BC HYDRO WANETA 2017 TRANSACTION EXHIBIT A-17
--

Re: British Columbia Hydro and Power Authority – Waneta 2017 Transaction Application – Project No. 1598933 – Commission Information Request No. 2

INFORMATION REQUEST NO. 2 TO BC HYDRO

**71.0 Reference: SENSITIVITY ANALYSIS
Exhibit B-1, Appendix N (Business Case), pp. 29–33, Appendix B, Figure 1 to 3, p. 65;
Exhibit B-8, BCUC IR 1.24.1, Economic Life**

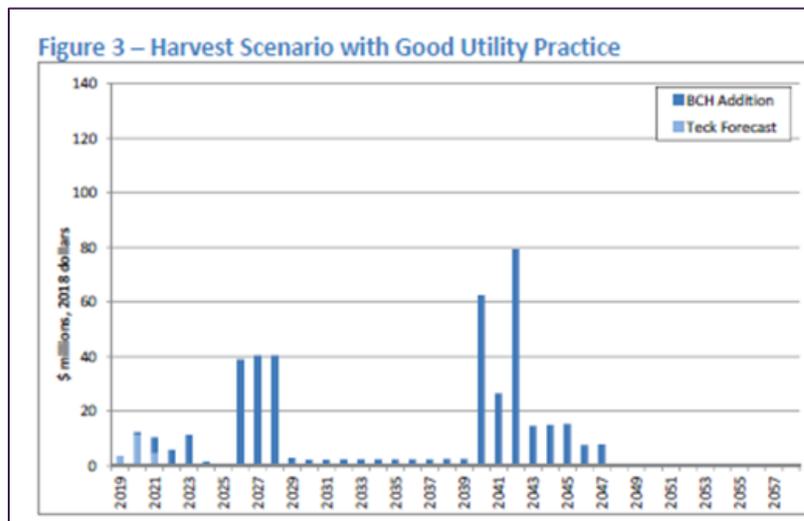
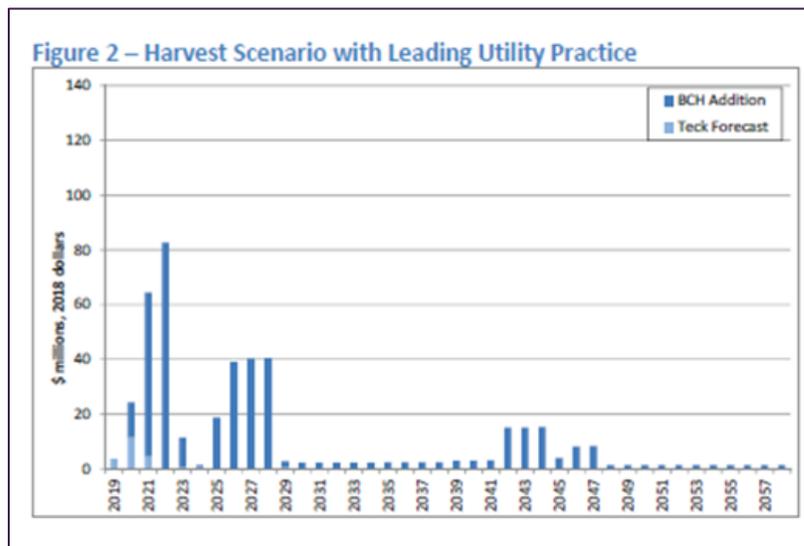
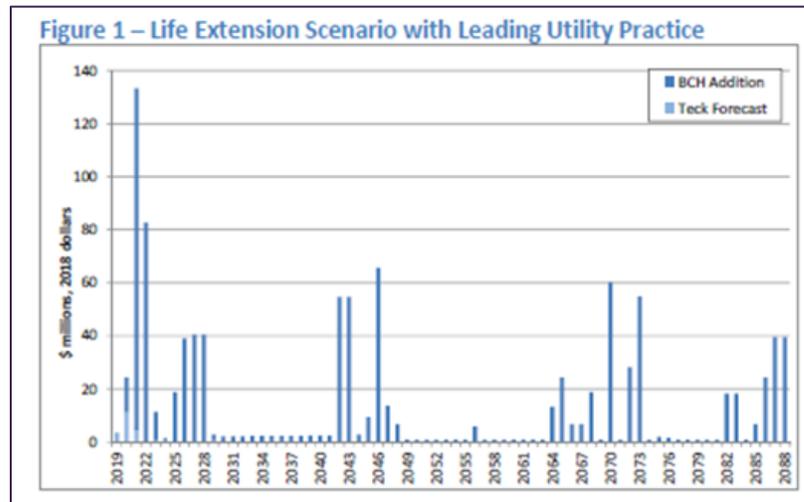
71.1 Please confirm that Figure 1 provides a good proxy of what BC Hydro would expect as a capital cost schedule going forward indefinitely every 70 years.

71.1.1 If not, what does Figure 1 represent?

- 71.1.2 If not, please provide a general schedule that reflects the periodic capital investments that would be required every 70 years to ensure the asset remains operational.

- 71.2 Please confirm that Figure 2 provides a good proxy of what BC Hydro would expect as a capital cost schedule going forward indefinitely every 40 years.

- 71.2.1 If not, please provide a general schedule that reflects the periodic capital investments that would be required every 40 years to ensure the asset remains operational.

In response to BCUC IR 1.6.3, BC Hydro provided the following Revised Figure 5:

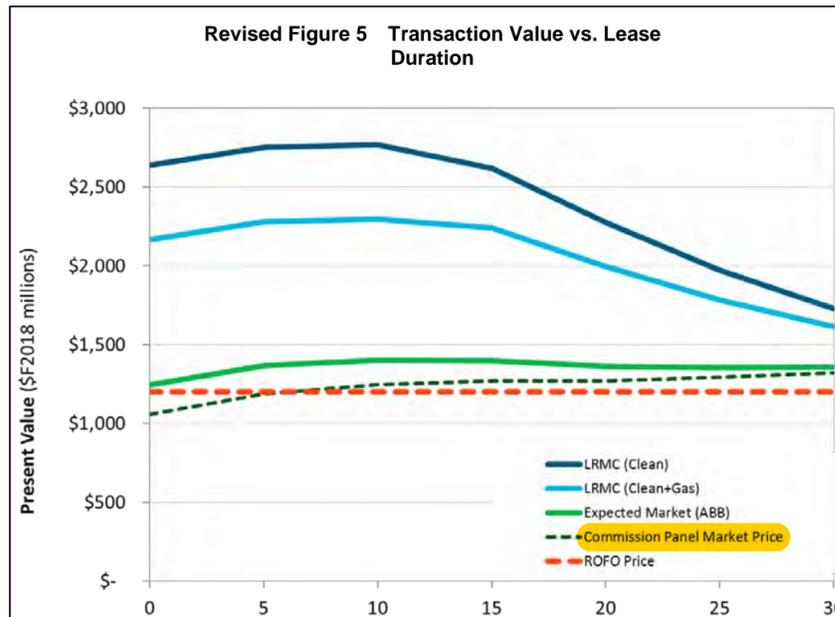
- 76.1 Please add the “un-risked transaction value range with 20-Year and 20-Year Post-Lease Value @ LRMC & Commission Panel Market Price”, assuming a mid-gap LRB for the valuation of the surplus/deficit, similarly to what BC Hydro presented in Figure 5 of Exhibit B-1-1.

- 76.5 Using the information from the Revised Figure 5 from BCUC IR 1.6.3 and the table from BCUC IR 1.6.7, please describe what happens to the value of the Waneta Transaction (under the LRMC Clean, LRMC Clean + Gas, ABB and Panel Mid-C pricing scenarios), if Teck defaults in Year 5, 10 or 15 versus the scenario where Teck does not default before the end of the lease and the lease

76.6 Please add the “Panel Mid-C energy price forecast” to the Revised Figures 5a, 5b and 5c provided in BCUC IR 1.6.5.

**91.0 Reference: BUSINESS CASE
Exhibit B-1, Appendix N-1, Figures 6 and 8, p. 4; Exhibit B-8, BCUC 1.6.2 and BCUC IR 1.16.3, BCUC IR 1.16.4
Rate impact analysis**

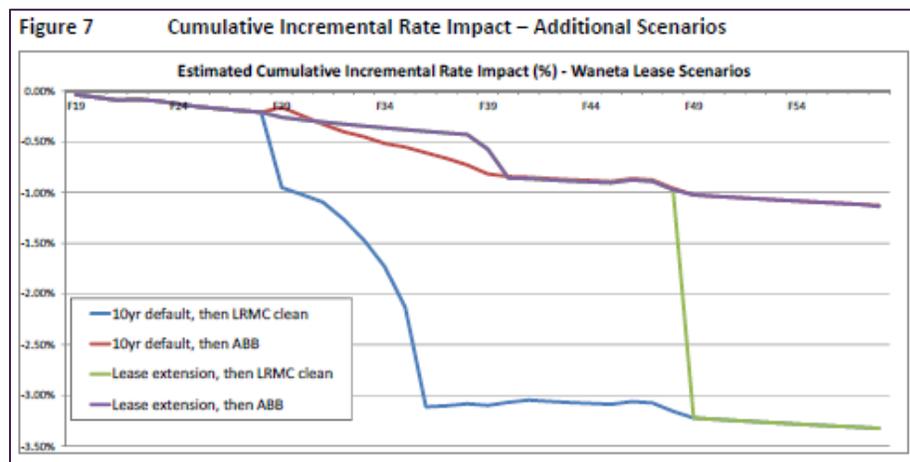
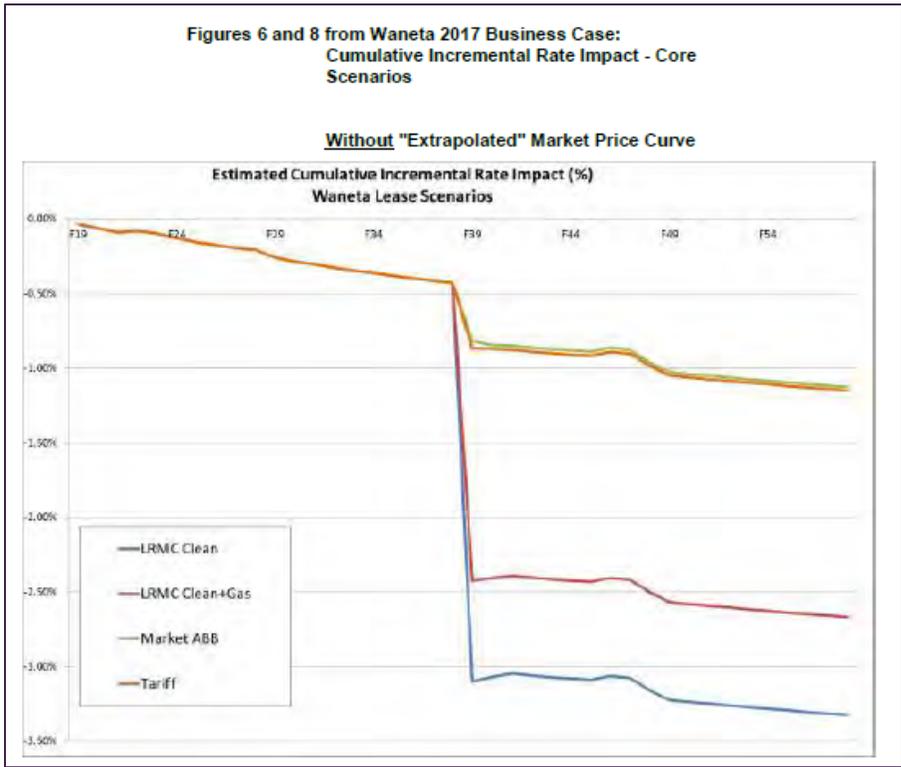
- 91.1 Please confirm, otherwise explain, that the statements made in the preamble apply to Figure 6/8.
- 91.2 Please confirm, otherwise explain, that the statements made in the preamble apply to Figure 7.
 - 91.2.1 If so, please clarify how BC Hydro took into account its LRB when it states “10 year default, then LRM Clean”.
 - 91.2.2 If so, please clarify how BC Hydro took into account its LRB when it states “10 year default, then ABB”.

91.3 Please confirm, otherwise explain, that the above statement applies to the "Tariff" scenario shown in Figure 6/8.

91.3.1 If confirmed, please revise the "Tariff" scenario assuming that the entire 2/3 Interest's generation is sold to Teck at the industrial tariff price (Revised Figure 6/8).

91.4 In the Revised Figure 6/8, please add a third market price scenario using the "Panel Mid-C market price" from the Site C Report. Please also add a line representing a 40% decrease in LRMC (Clean).

91.5 Please provide a Revised Figure 7 adding four lines to Figure 7, replacing "ABB market price" with "Panel Mid-C market price" and replacing LRMC Clean with a 40% decrease in LRMC Clean.

91.6 Please provide additional versions of the Revised Figure 6/8 and Figure 7 (those from the questions immediately above) using the Small Gap LRB and Large Gap LRB.

91.7 Please provide additional versions of the above Revised Figure 6/8 and Figure 7 using 2.9%, 5.4% and 6.0 per cent financing, based on Mid Gap LRB.
